Downtown West

Design Standards
and Guidelines
Errata

April 15, 2021

FIGURE 4.50: Required (R) and complementary (C) Gateway to San José programmatic elements diagram

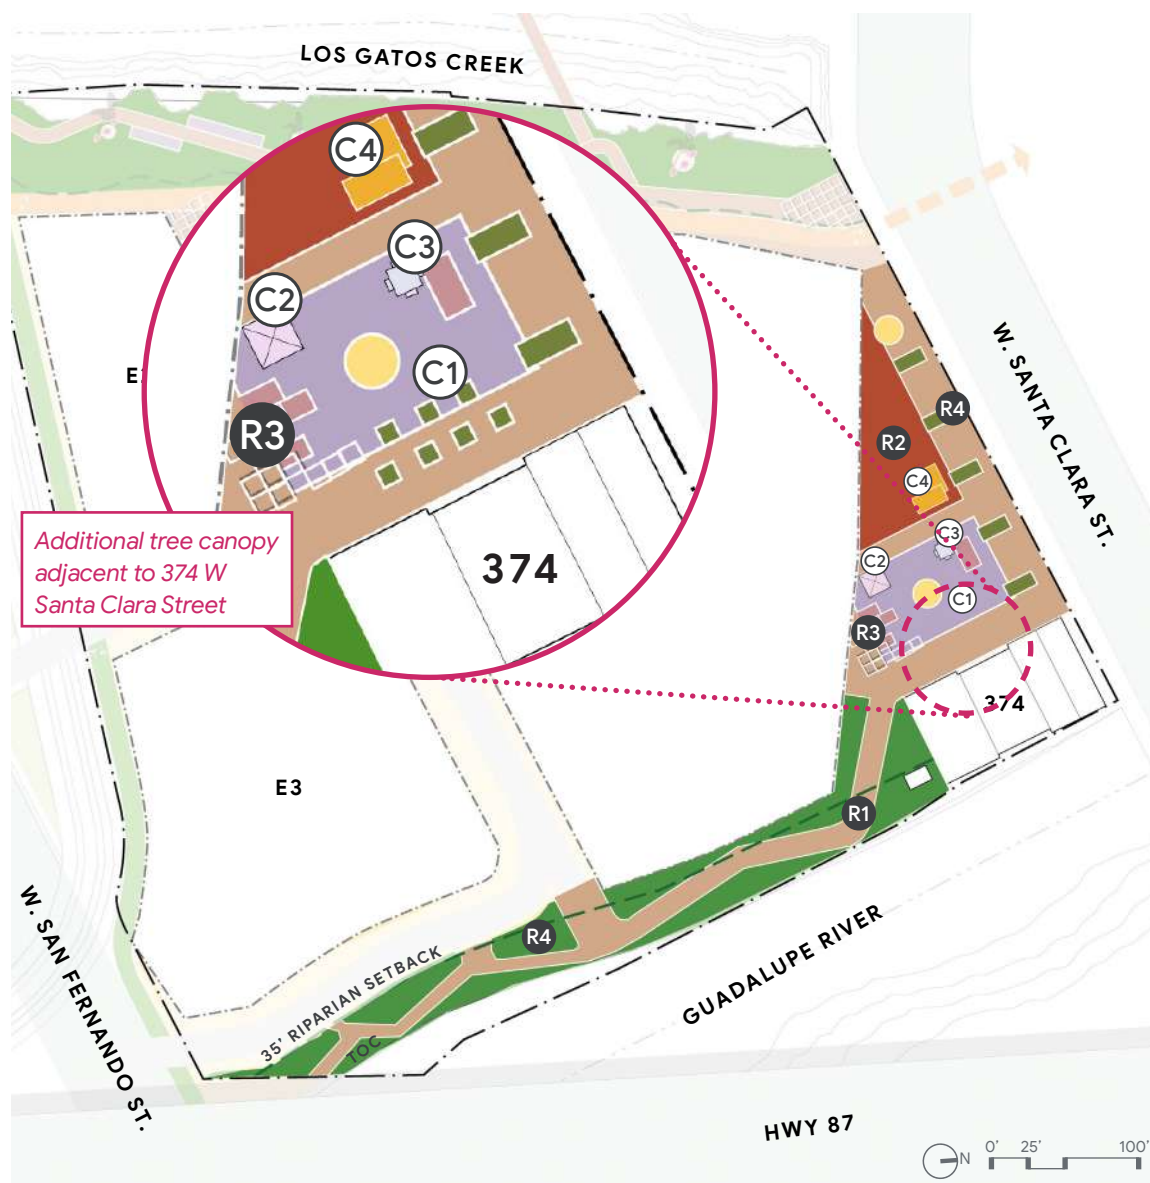
ERRATA ID	DWDSG PAGE NUMBER	DWDSG CHAPTER	DWDSG CONTENT	DESCRIPTION OF UPDATES
ER_10c	134	Open Space	Figure 4.49	Additional tree canopy adjacent to 374 W Santa Clara Street
ER_10d	136	Open Space	Figure 4.50	Additional tree canopy adjacent to 374 W Santa Clara Street
ER_10e	148	Open Space	Figure 4.60	Additional tree canopy adjacent to 374 W Santa Clara Street
ER_11	150	Open Space	Table 4.15	Addition of “California Hazelnut, <i>Corylus cornuta</i> Marsh. var. <i>californica</i> ” to plant species list
ER_12	156	Open Space	S4.25.4	“Serviced and unserviced pavilion structure that use glazing as a material shall provide glazing units with visible light transmittance below 60 percent which shall not count toward the required transparent area. Existing structures that are relocated as pavilions shall be exempt from transparency requirements. ”
ER_13	156	Open Space	S4.25.6	“Public restrooms, park maintenance and storage facilities, and park management offices shall be permitted supportive structures for open spaces active uses; see Section 3.1. No single park maintenance structure shall exceed 1,500 square feet in interior area. Park maintenance structures shall not exceed 20 feet in height above finished grade as measured to top of roof. Park maintenance structures are permitted in either the open space or the interior of an adjacent building, new development blocks, or other space outside of street right-of-way. If provided as a standalone structure in the open space, the structure size cannot exceed the maximum cover limit described in Table 4.16.”

FIGURE 5.7: Architectural requirement summary

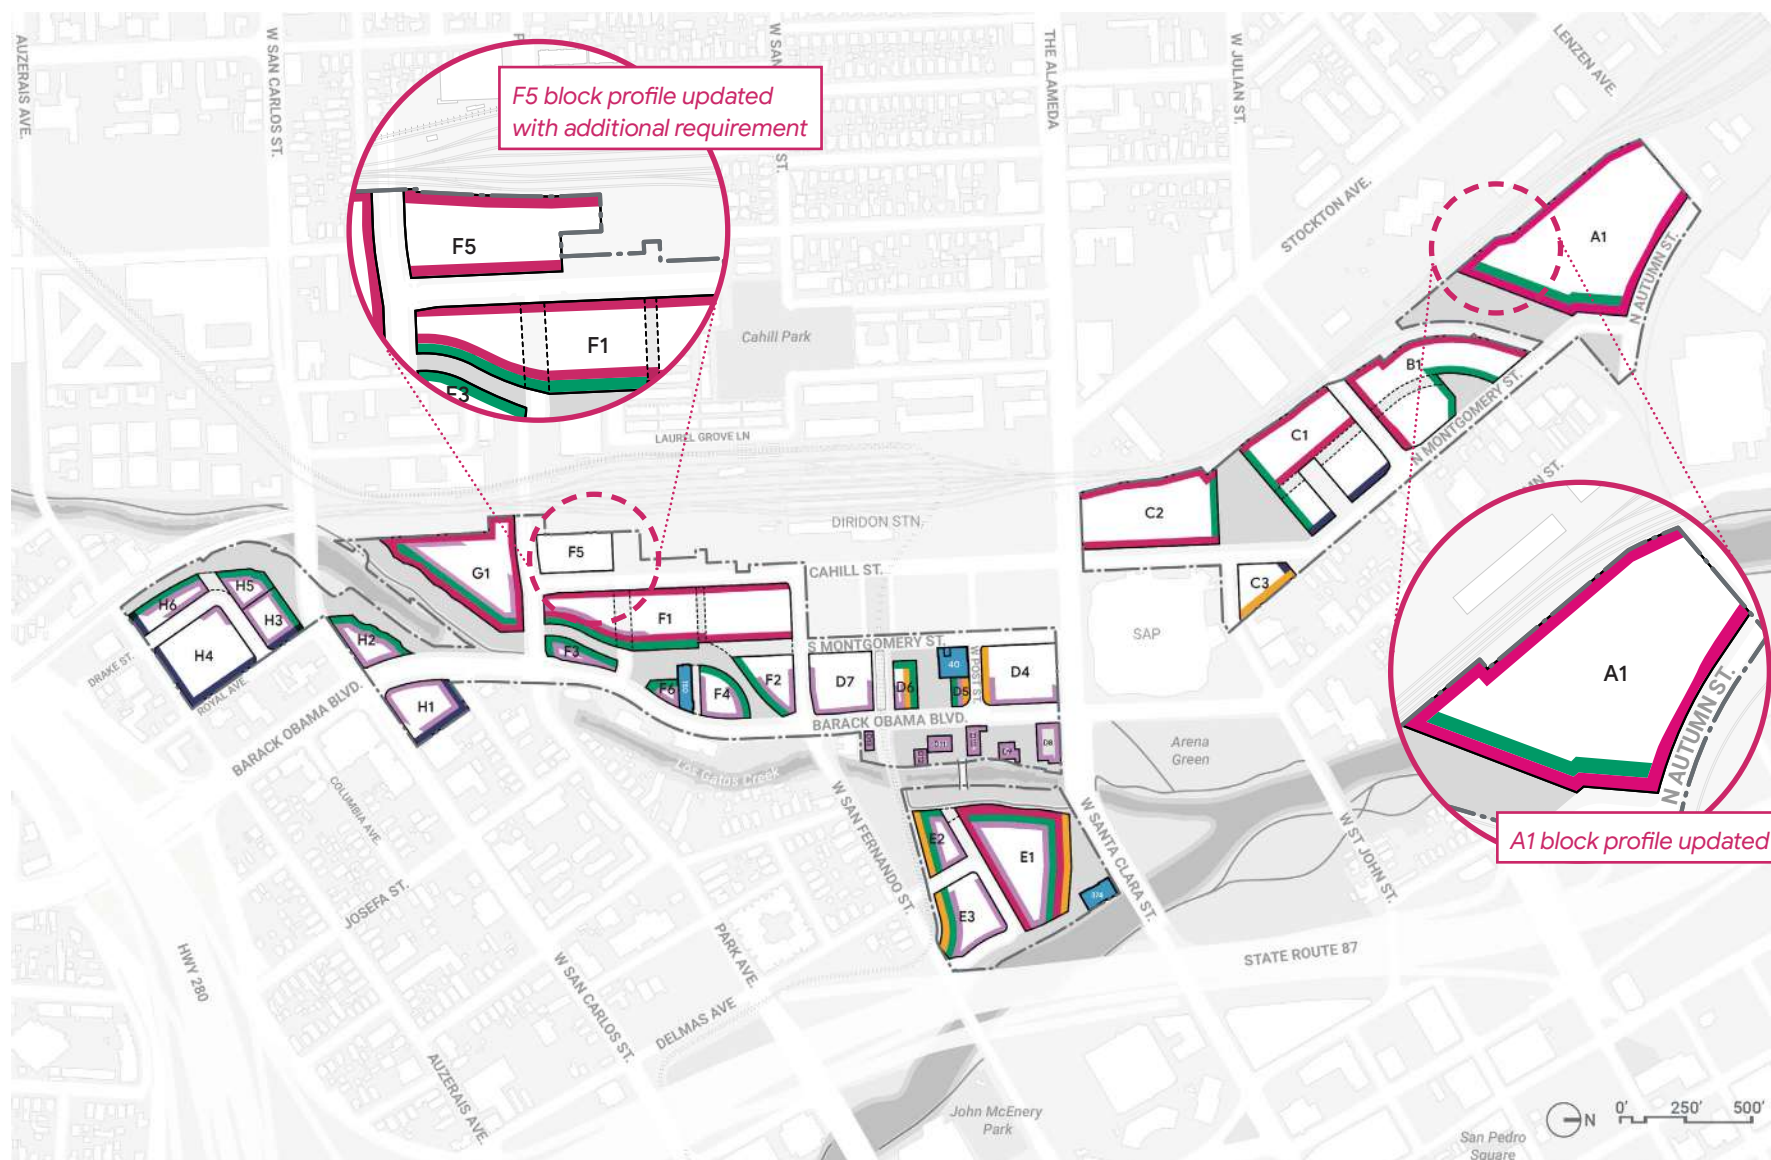
ER_14	170	Buildings	Figure 5.7	Addition of long facade demarcation on F5 east (secondary) and F5 west (primary).
ER_15	171	Buildings	Table 5.1	Addition of long facade demarcation on F5
ER_16	173	Buildings	Figure 5.9	Site boundary changes at F5 and A1
ER_17	176	Buildings	S5.5.7	<p>“ • The existing structure at block D13 shall be replaced by the relocated 35 South Autumn Street (Barack Obama Boulevard) main structure (see S5.15.3). The structure from 35 South Autumn Street shall be relocated within the building footprint of 74 South Autumn (Barack Obama Boulevard) and outside of the 50-foot Los Gatos Creek Riparian Setback.</p> <p>• If the property owner elects to demolish any building on blocks D9 or D12-D12-or-D13, the property owner is permitted to replace the demolished built area in a new building elsewhere in Creekside Walk. Replacement structures for blocks D9 or D12-D12-and-D13 shall not encroach into the 50-foot Los Gatos Creek Riparian Setback. Individual replacement structures shall be permitted to exceed the gross square footage of the existing structure in accordance with the square footage limits of additions described below. Replacement structures are subject to applicable standards in Sections 5.6, 5.7, 5.8, and 5.13.”</p>

FIGURE 5.30: Primary long facade and secondary long facade locations

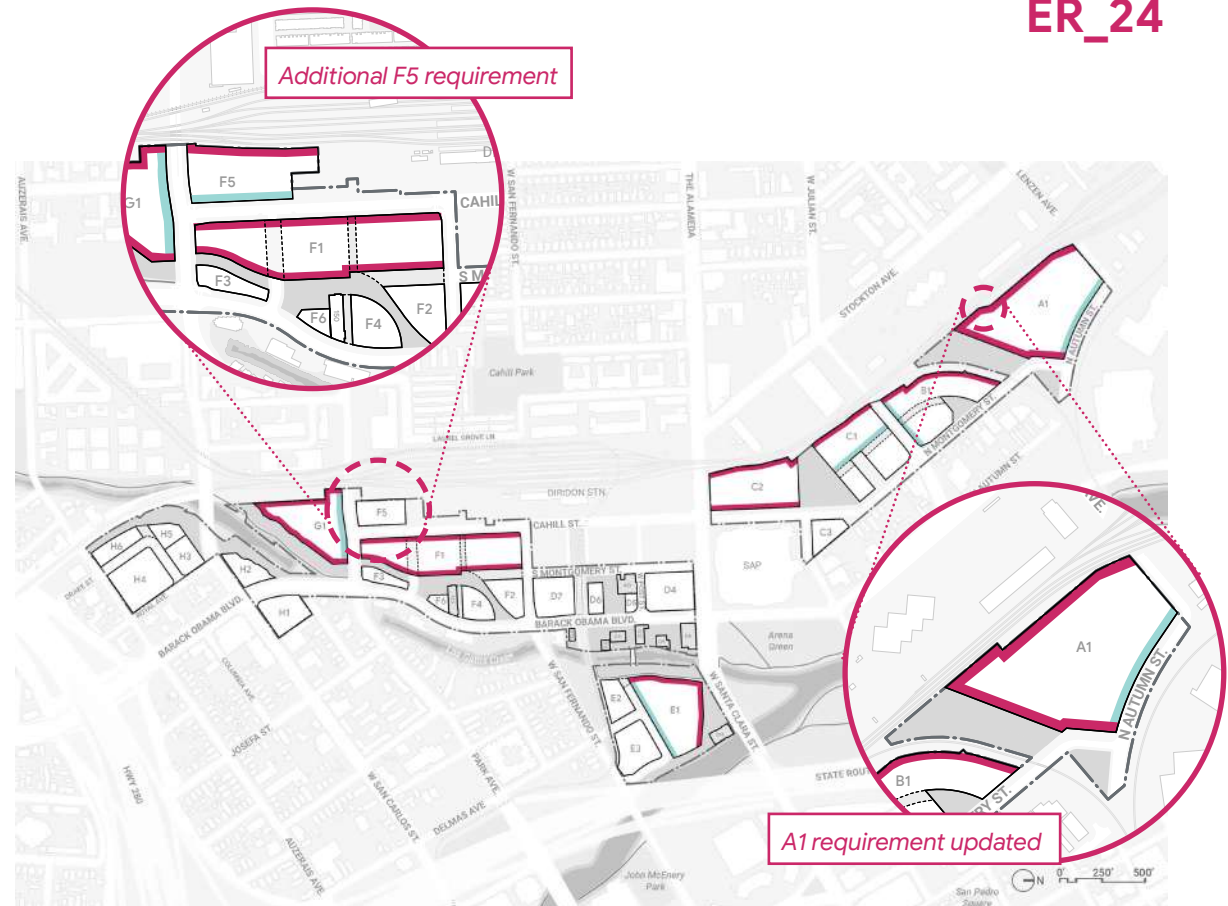
ERRATA ID	DWDSG PAGE NUMBER	DWDSG CHAPTER	DWDSG CONTENT	DESCRIPTION OF UPDATES
ER_21	185	Buildings	S5.8.2	“Frontage along Los Gatos Creek — including altered or replacement structures on blocks D8, D9, D10, D11, D12, D13, and new development on E1, E2, G1, and H2 — shall be exempt from this requirement to enhance adjacent riparian habitat within the Los Gatos Creek Riparian Corridor . See Section 5.17.”
ER_22	187	Buildings	S5.8.4	“Ground floor active uses within residential buildings located on blocks C1, H1, H3, H4, H5, and H6 north of West St. John Street and south of West San Carlos Street shall provide a minimum 12 feet clear height to finished ceiling shall .”
ER_23	197	Buildings	S5.10.2	“Skyline level occupiable projections on the south facade of block A1 and the north facade of block C2 shall be exempt from the dimensional requirements above and shall...”
ER_24	202	Buildings	Figure 5.30	Addition of long facade demarcation on F5

FIGURE 6.53: Conceptual off-street parking garages

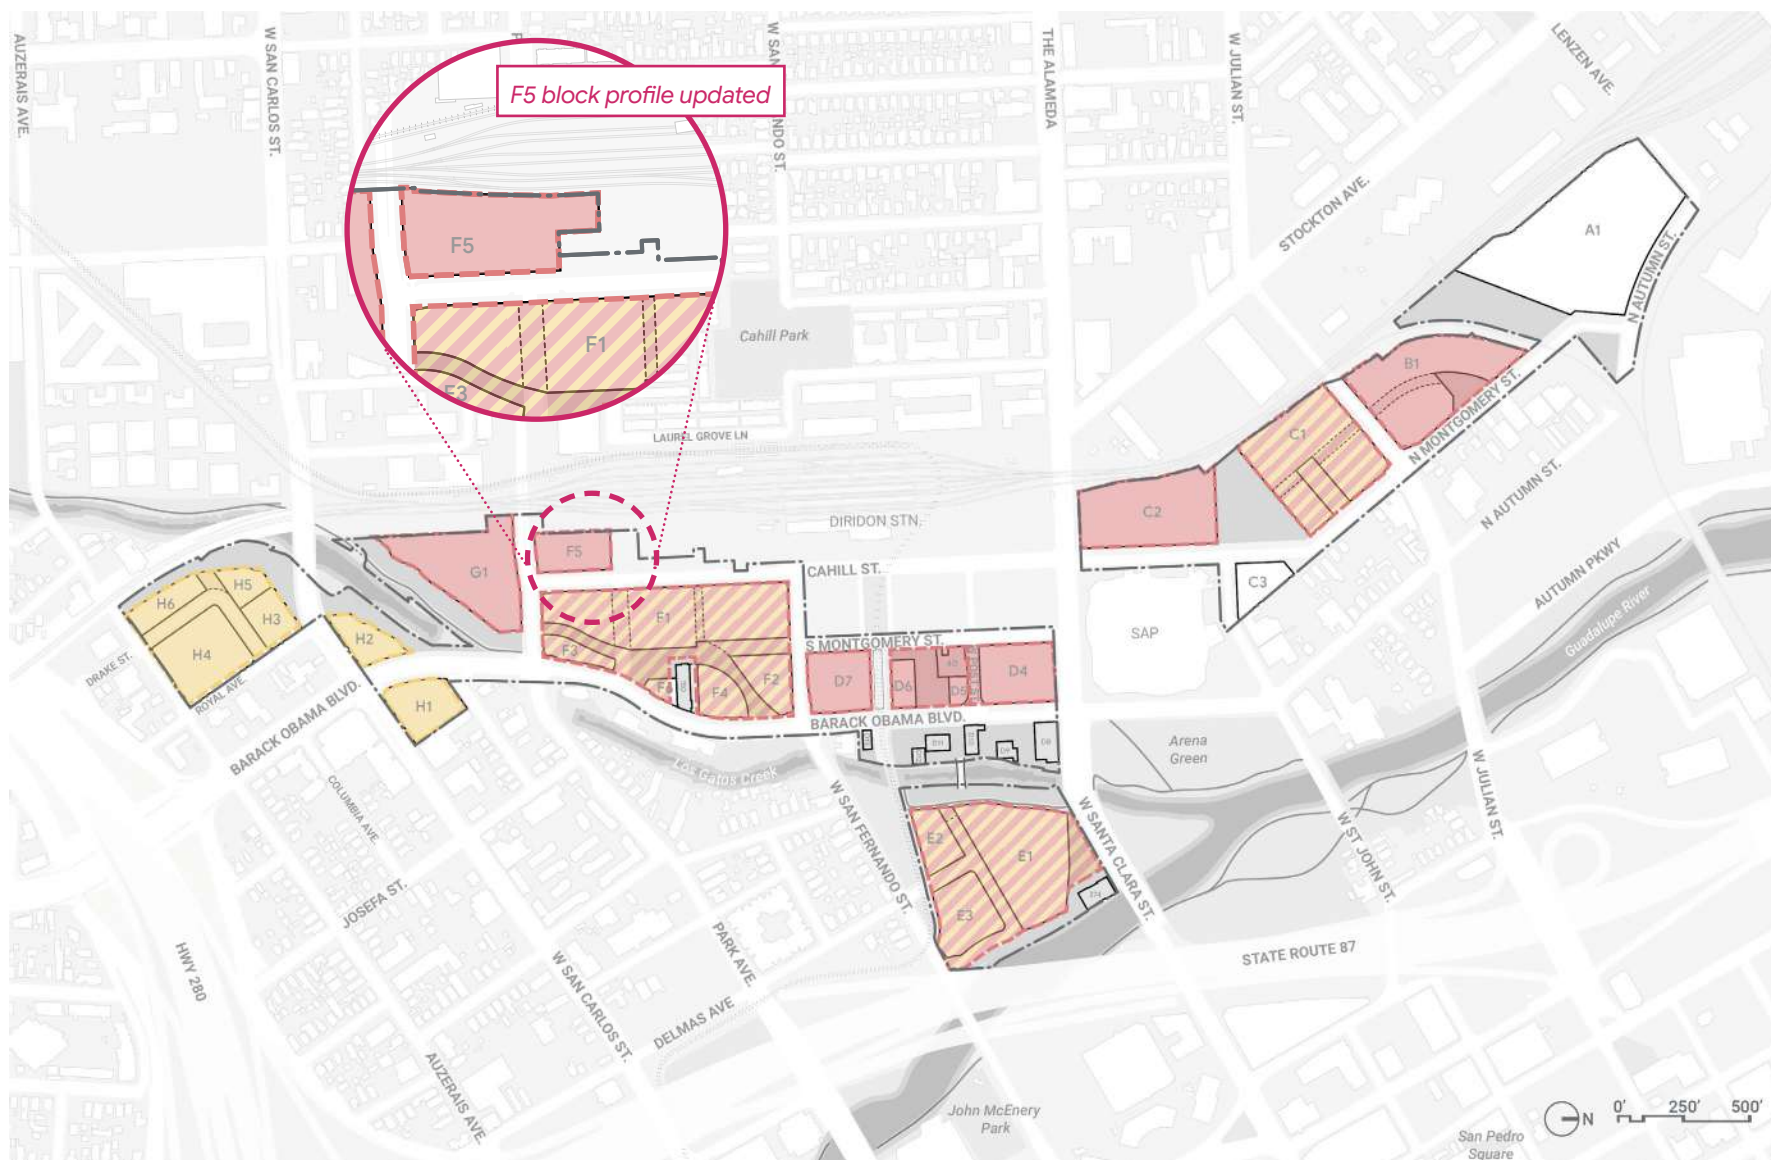
ER_28	297	Mobility	Figure 6.53	Site boundary changes at F5 and A1
ER_29	299	Mobility	Figure 6.54	Site boundary changes at F5 and A1
ER_30	307	Lighting and Signage	S7.3.3	“All open space lighting, excluding lighting for art, shall install lighting that has have a color temperature of less than or equal to 2,700 2700 kelvins. Lighting requirements for art adjacent to a riparian corridor shall follow S7.4.7.”
